REVISIONS AND CORRECTIONS

CURBS

TIMBER CURB

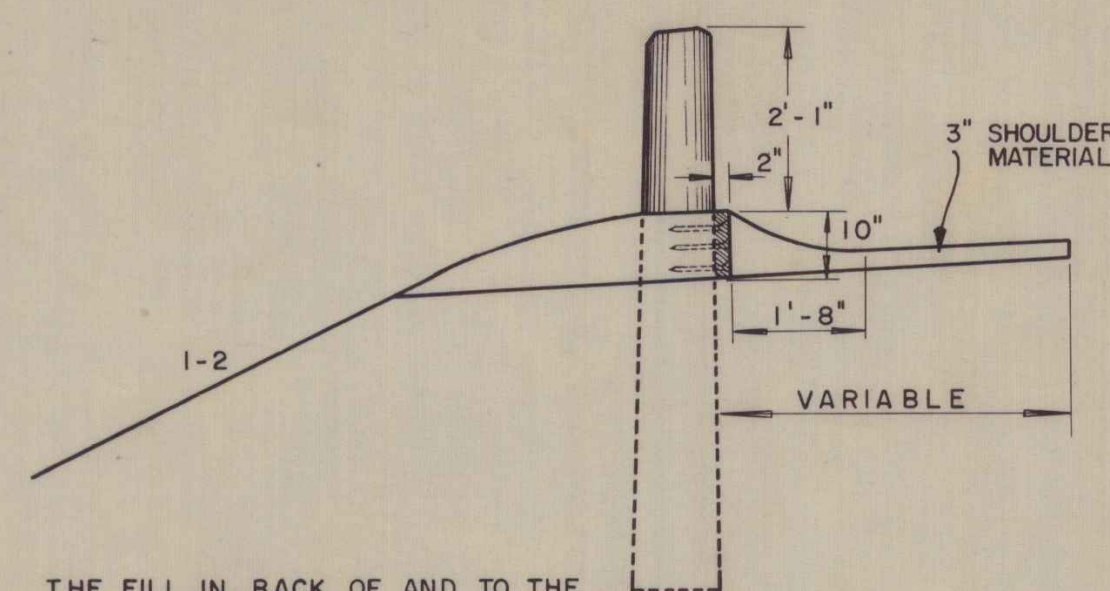
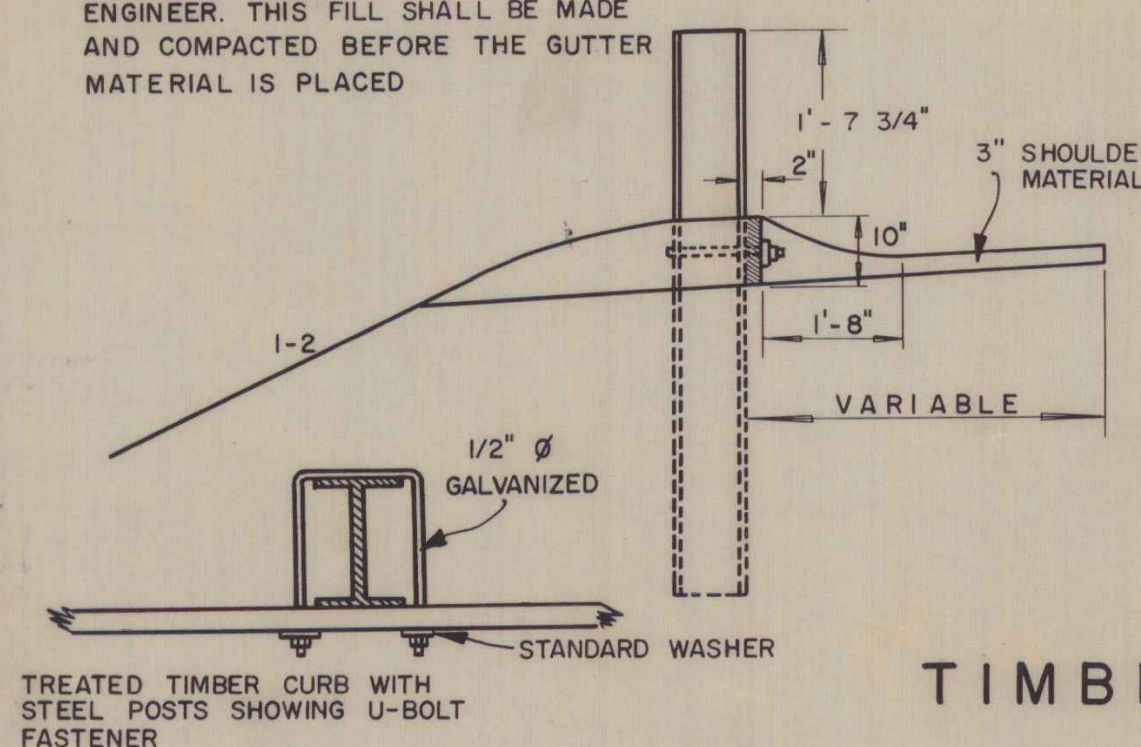
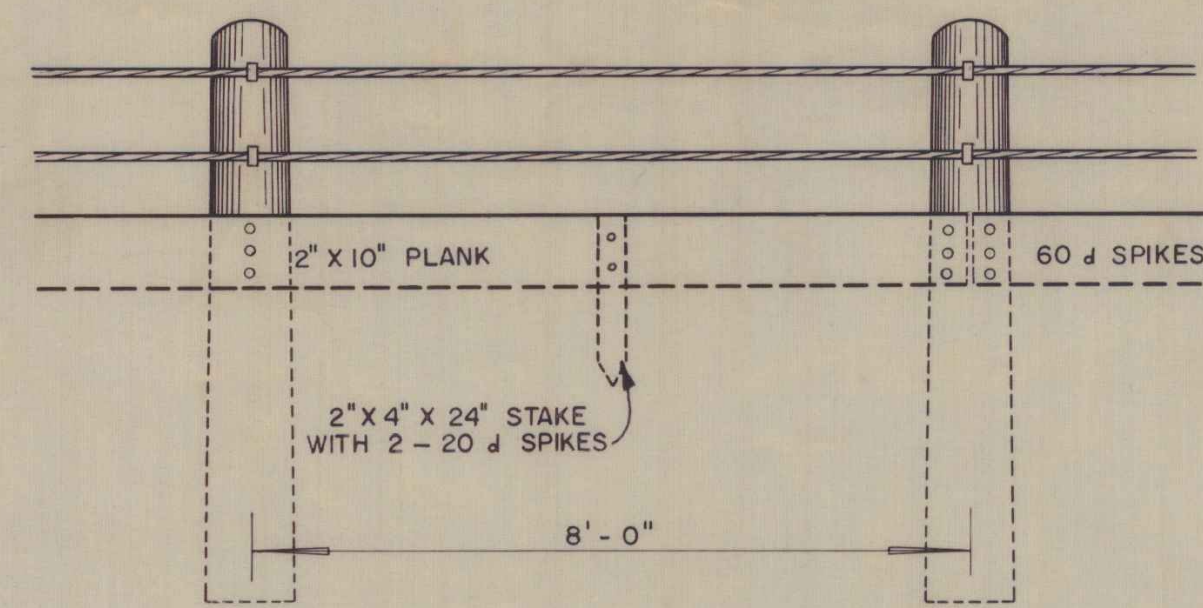
THIS SHEET SUPERCEDES SHEET C-1, APPROVED MAY 26, 1958
DETAIL OF GRANITE CURB END ADDED JUNE 16, 1959
BITUMINOUS CONCRETE CURB ADJACENT TO BITUMINOUS CONCRETE SIDEWALK REVISED FROM TYPE II TO TYPE I.-JUNE 16, 1959
STAKES ADDED TO TIMBER CURB. JULY 20, 1959
LOCATION OF BIT. CONC. CURB W/GUARD RAIL, WAS CHANGED JULY 29, 1959
HEIGHT OF GRANITE SLOPE EDGING CHANGED FROM 7" TO 6" DEC. 9, 1959.
WIDTH OF GRANITE SLOPE EDGING CHANGED FROM 3' TO 5". SEPT. 14, 1960
